STAFF REPORT

SUBJECT: H-2023-0058 Cityside Storage – MDA, CUP

LOCATION: 2755 N. Eagle Road in the NE ¼ of Section 5, Township 3N., Range 1E.

A. Site Plan (12/06/23)

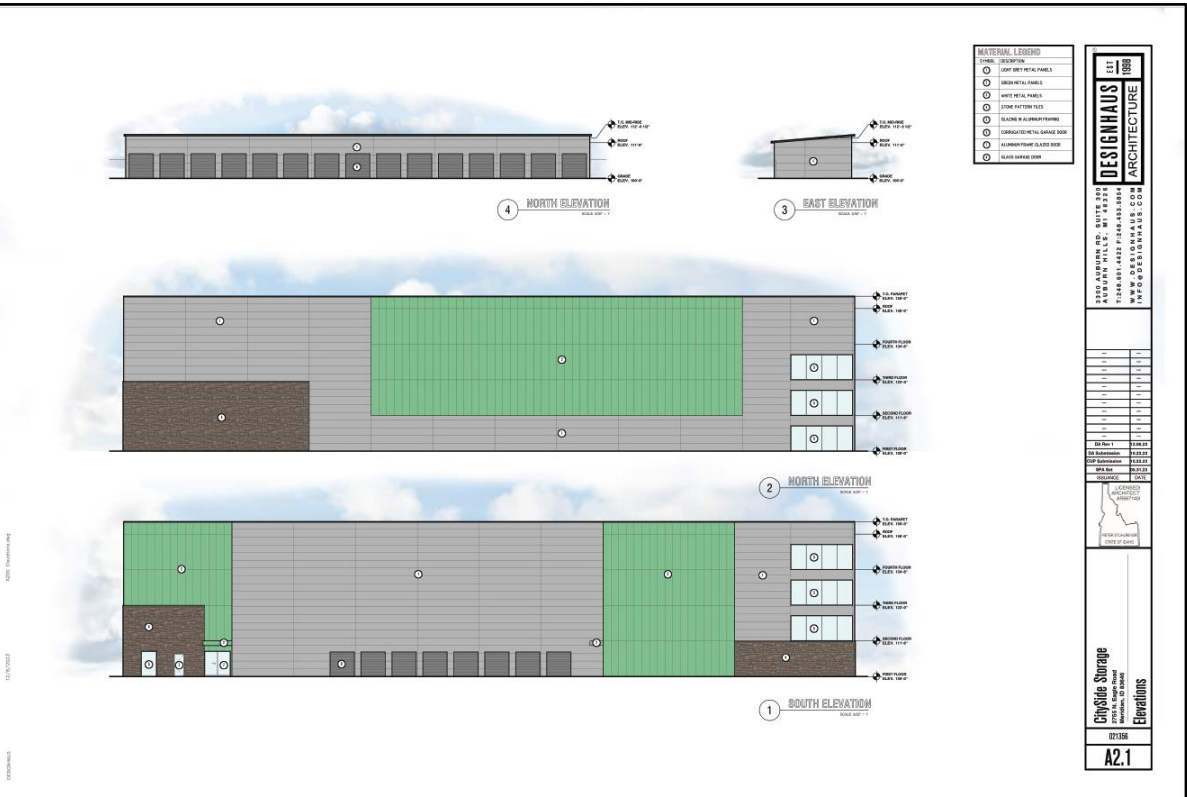
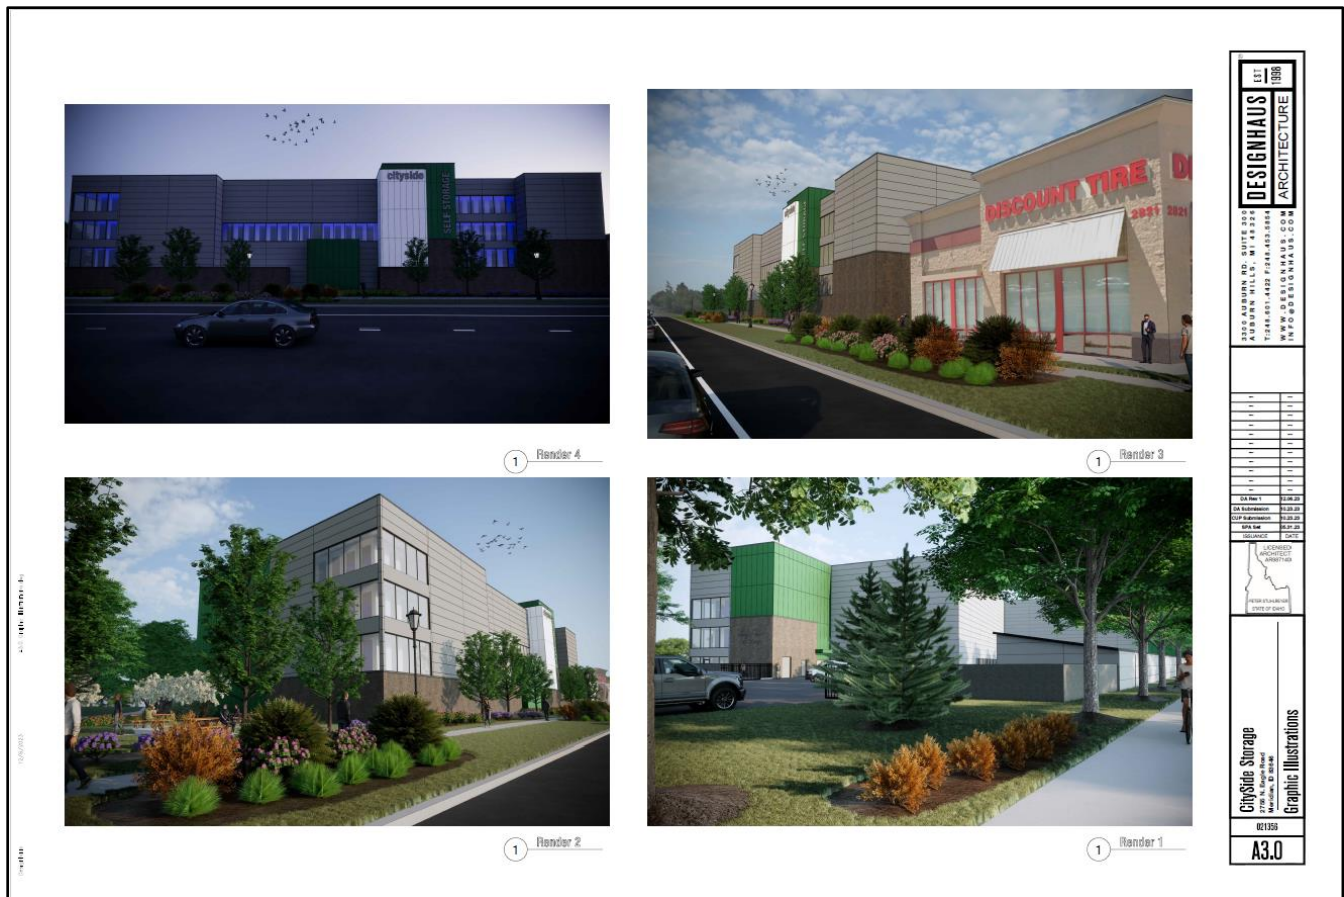
Staff finds the proposed storage facility, self-service if approved at the requested height and square footage would not maintain compatibility with existing structures which is crucial not only for aesthetics but also for the functional integration of the new development into the community.

The proposed height will not be harmonious with adjacent residential and commercial uses and will negatively impact these uses as it may lead to overshadowing of neighboring structures, and alterations to the area's character which are a concern. Therefore staff recommends the building height not exceed 35 feet in height which is consistent with the adjacent structures in the area.

Based on the information provided above, staff is not in favor of recommending approval of the Development Agreement modification to increase the square footage from 32,500 to 135,000 with a 32,500 building footprint. Staff is in favor of recommending approval of the Development Agreement modification and CUP for a storage facility with a maximum height of 35 feet and building square footage of 32,500.

- 1.1 The new DA shall be signed by the property owner and returned to the Planning Division within six (6) months of the City Council approval of the Findings. The DA shall, at minimum, incorporate the following provisions:
 - a. Future development of this site shall be generally consistent with the concept plan and conceptual building elevations included in Section VIII and the provisions contained herein.
 - b. The future use of this site is limited to the self-service storage facility, office, and retail uses. All buildings shall not exceed thirty-five (35) feet in height.
